## MEETING NOTICE – SITE REVIEW COMMITTEE

**Date/Time: Wednesday May 26<sup>th</sup> 2021 (5:30 P.M.)**

#### **5. DISCUSSION AND ACTION – Request for a new 1,024 square foot detached accessory building (1200 Centennial Centre Blvd., HB-2490) (Page 7)**

#### **8. DISCUSSION AND ACTION - Consider a 136 unit, 8 building leased residential development with associated site improvements (1260-1274 Lear Ln., HB-L159) (Page 32)**

# ARVADA II APARTMENTS

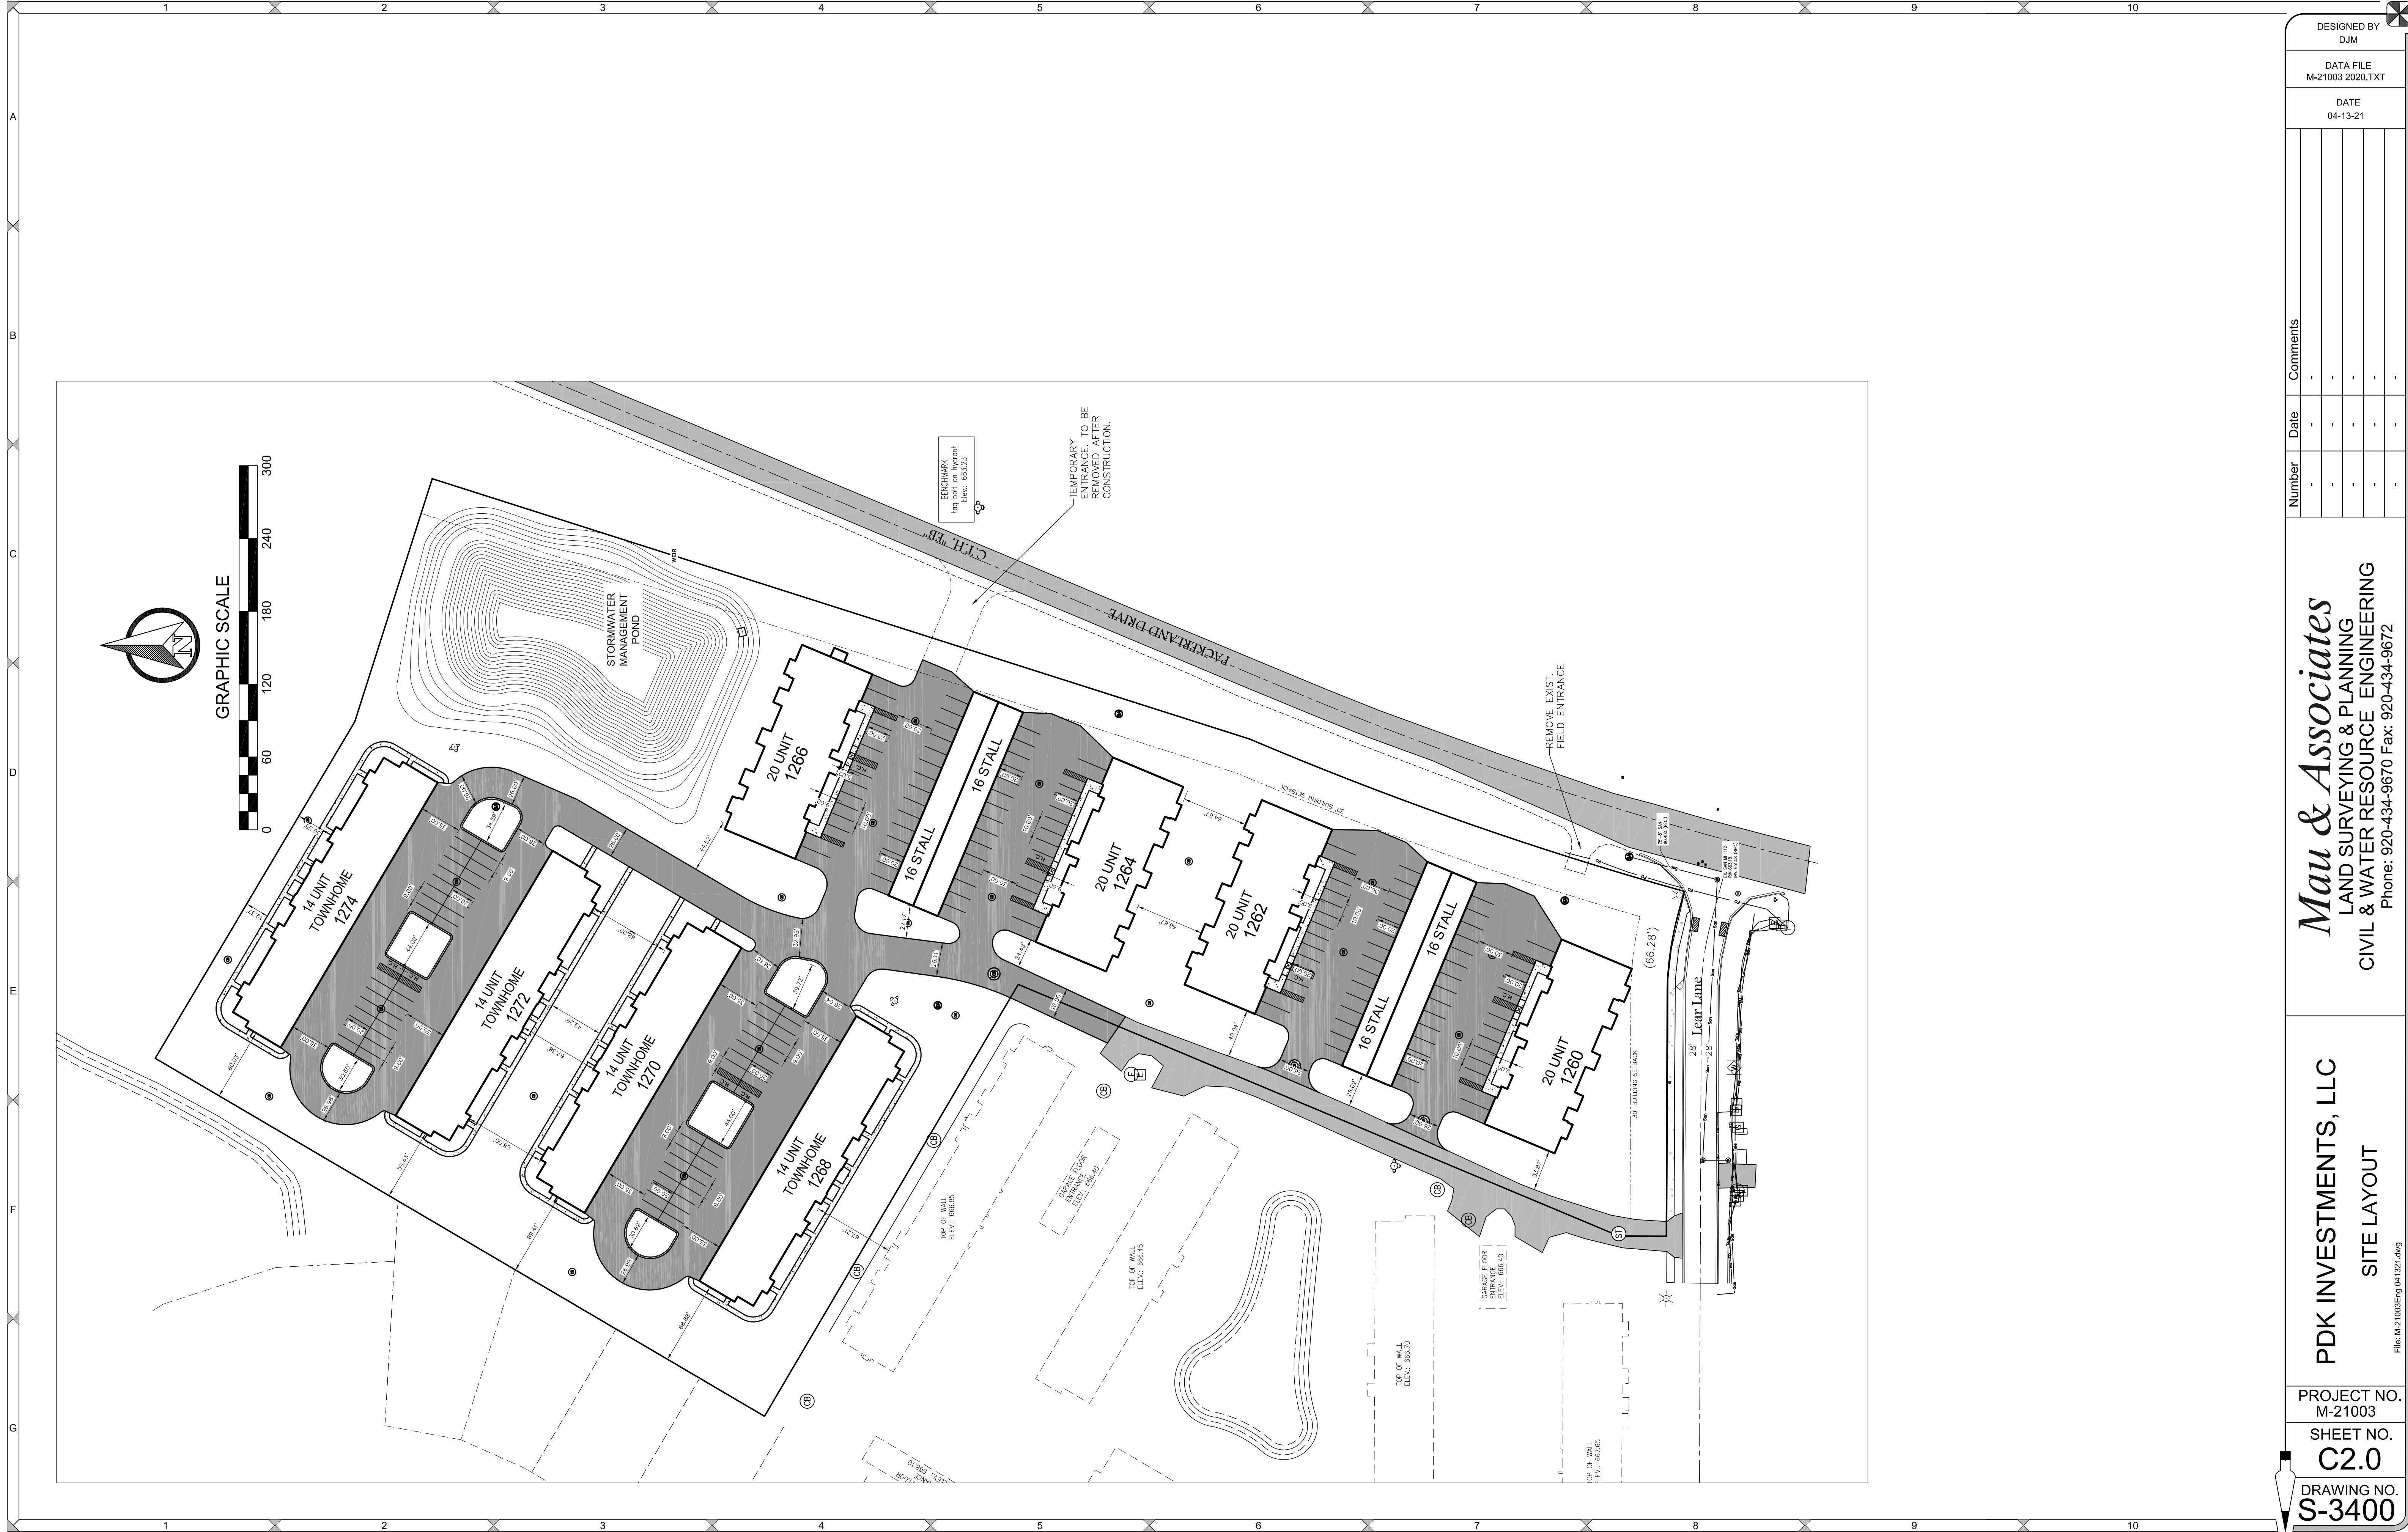
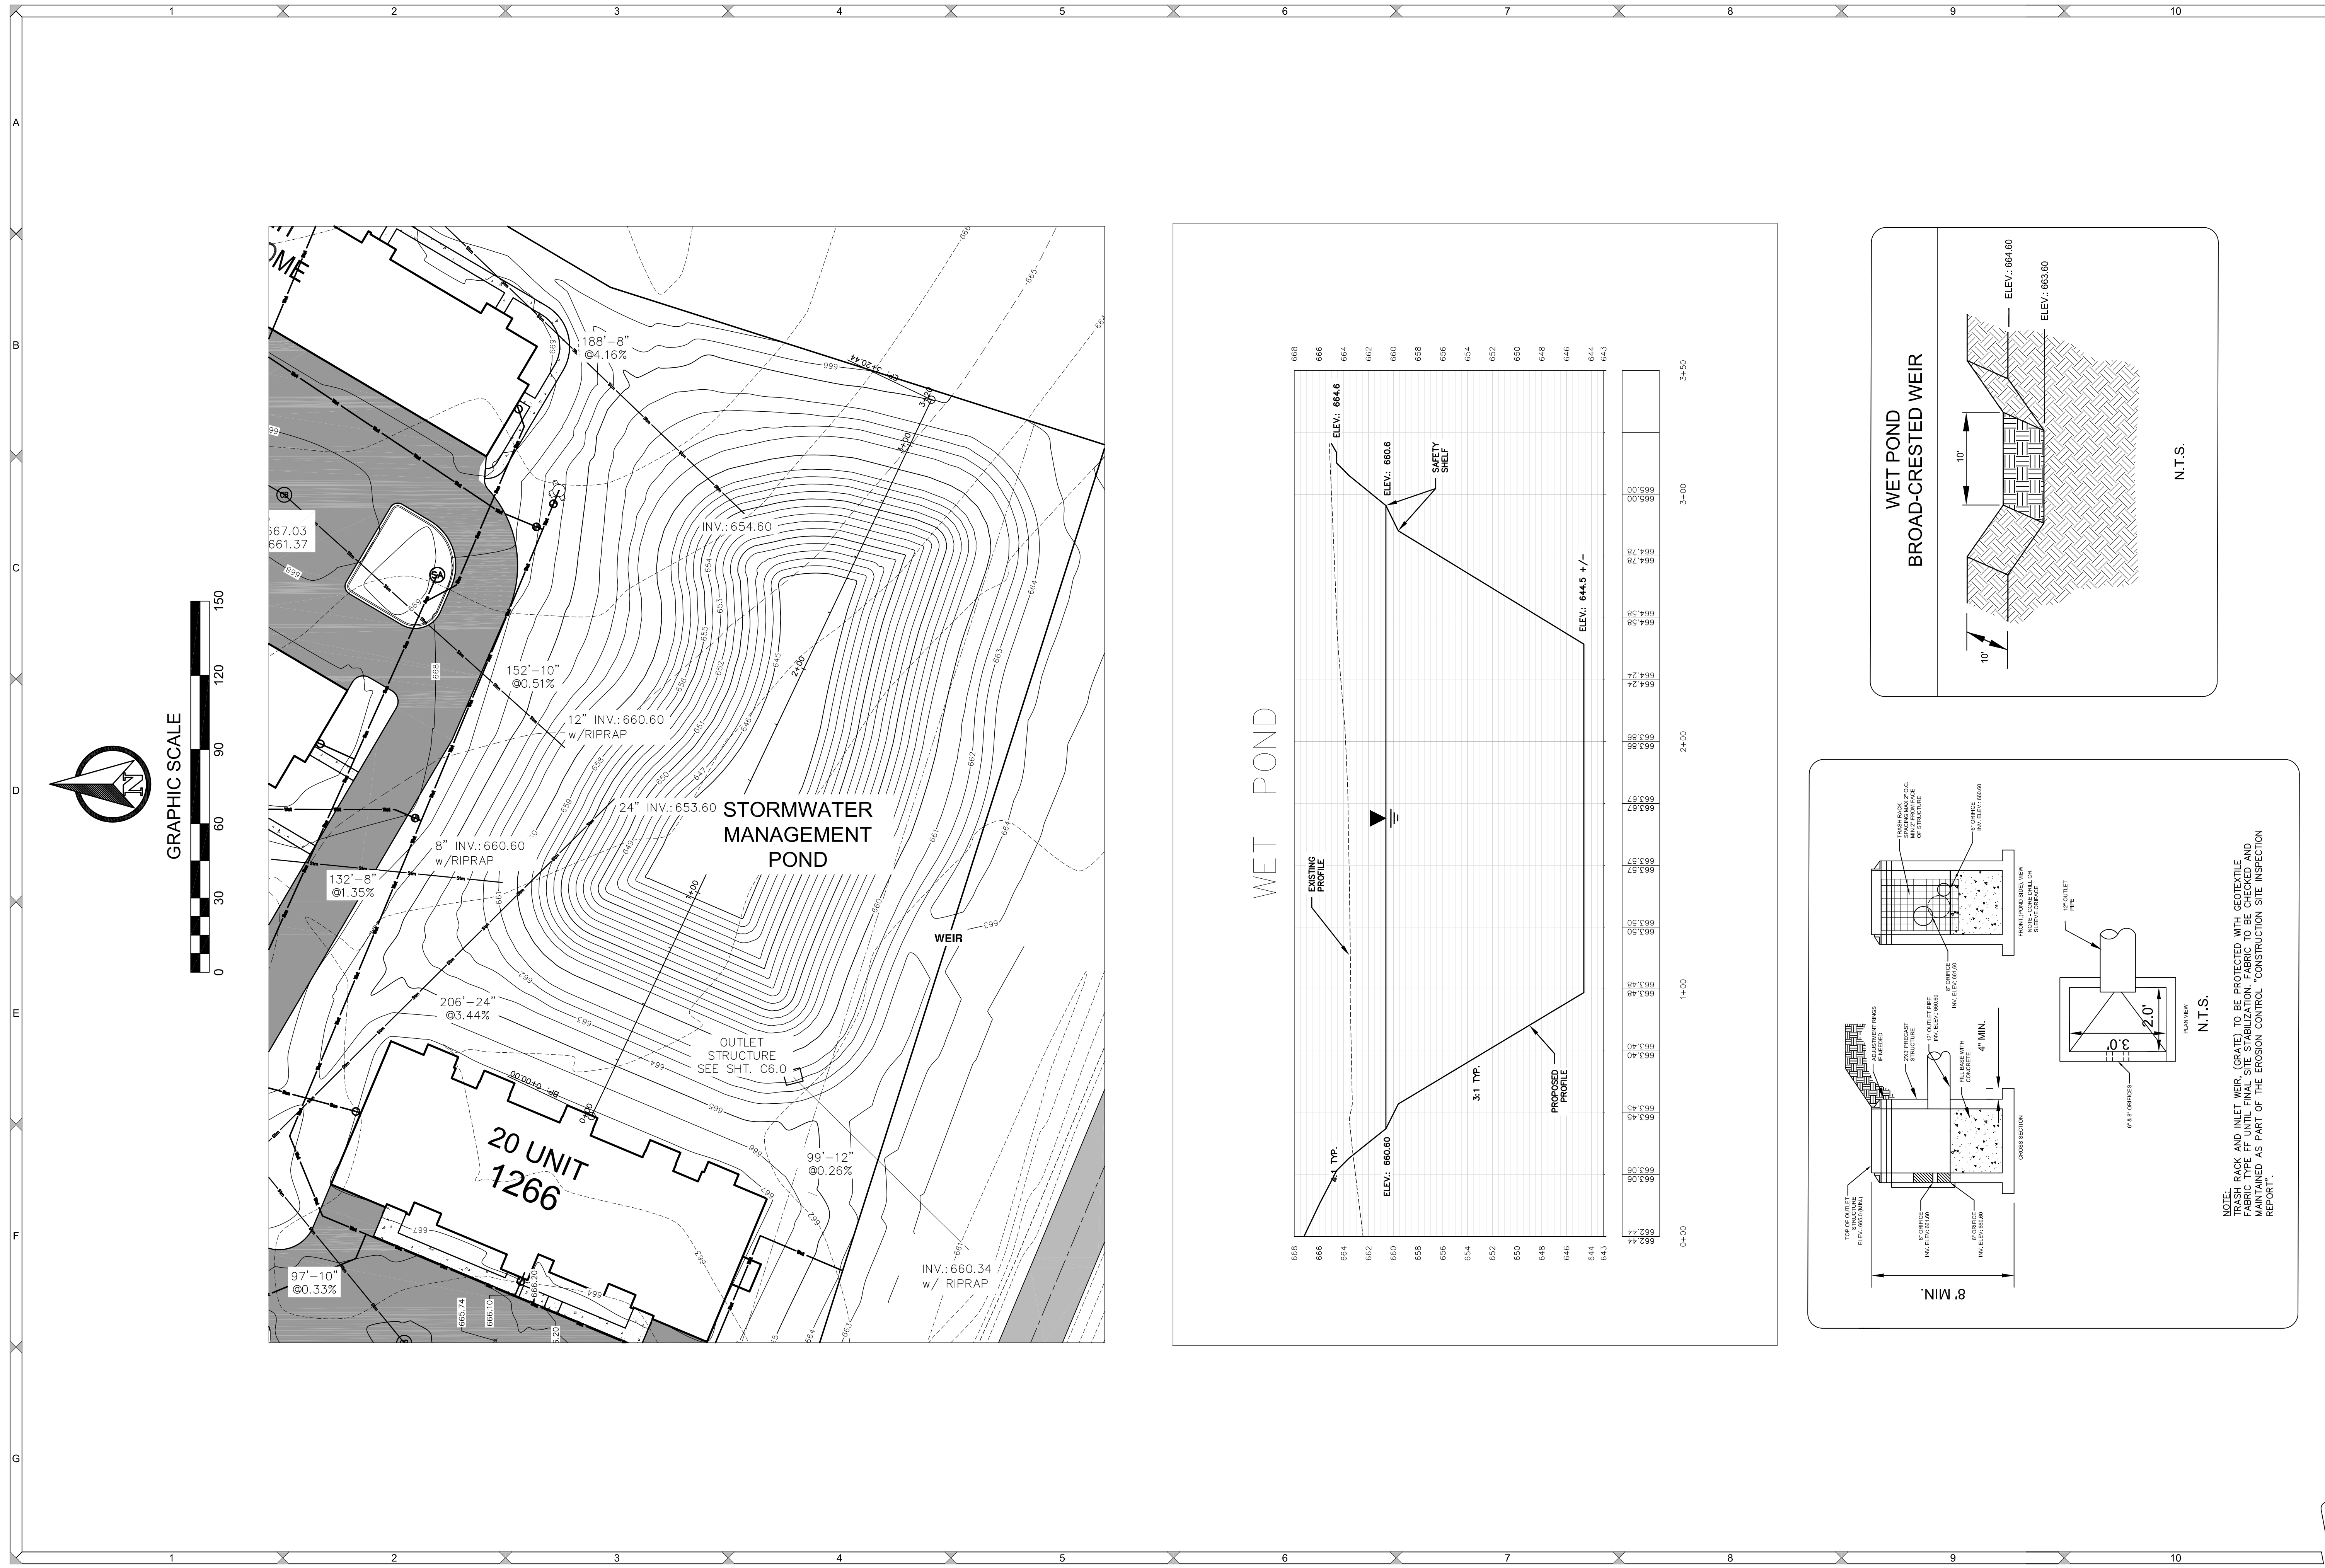
- A. Zoning:** PDD #2: Orlando/Packerland Planned Development District
- B. Green Space:** 43.5% after development
- C. Setbacks:** This development complies with all applicable setbacks (proposed 30' (front/Packerland and Lear), 59' (rear), 20' (side))
- D. Parking:** The requirements for multi-family developments are 1 stall per bedroom and 50% of the required parking must be enclosed. Staff review identified a total of 236 bedrooms. Thus 236 parking stalls are required, with 118 of those being enclosed (garage stalls.) The development provides a total of 288 parking stalls with 172 of those stalls being enclosed/garage stalls.
- E. Fire Dept. and Police Dept.:** The plans presented have been reviewed and accepted by both the Police Chief and Fire Chief with the condition that either the “temporary” access drive from Packerland Dr. remain after

- F. Storm Water:** Storm water from this phase will be collected by internal catch basins through the site and discharge to a new storm water management pond to the rear of the development then will discharge to the roadway ditch along Packerland Dr.
- G. Refuse Collection:** No additional collection area is noted on the plans, but Staff will verify prior to the meeting. They may be utilizing the existing collection area within the existing development, if large enough to accommodate the increased units.

**Section 3, Landscaping Plan:** Foundation planting proposed around both the 14-unit and 20-unit buildings with additional landscape screening between the Packerland Dr. and the 20-unit buildings. Additionally, along the west property line the 6' high white vinyl fence is proposed to be extended along with some trees to create a buffer between the multi-family development and the adjacent single-family subdivision. This fencing will extend from the existing fence in phase 1 and continue to the end of the phase 2 development.

- 1. That either the “temporary” access drive from Packerland Dr. remain after the development is completed and be constructed as a second permanent, code complying access drive into this phase of the entire complex, or another viable access point to the rear of this 2<sup>nd</sup> phase that is approved by the Village Fire Chief and Village Police Chief.
- 2. Installation of directional address signage within the proposed and existing developments working with Village Departments to verify most functional locations.
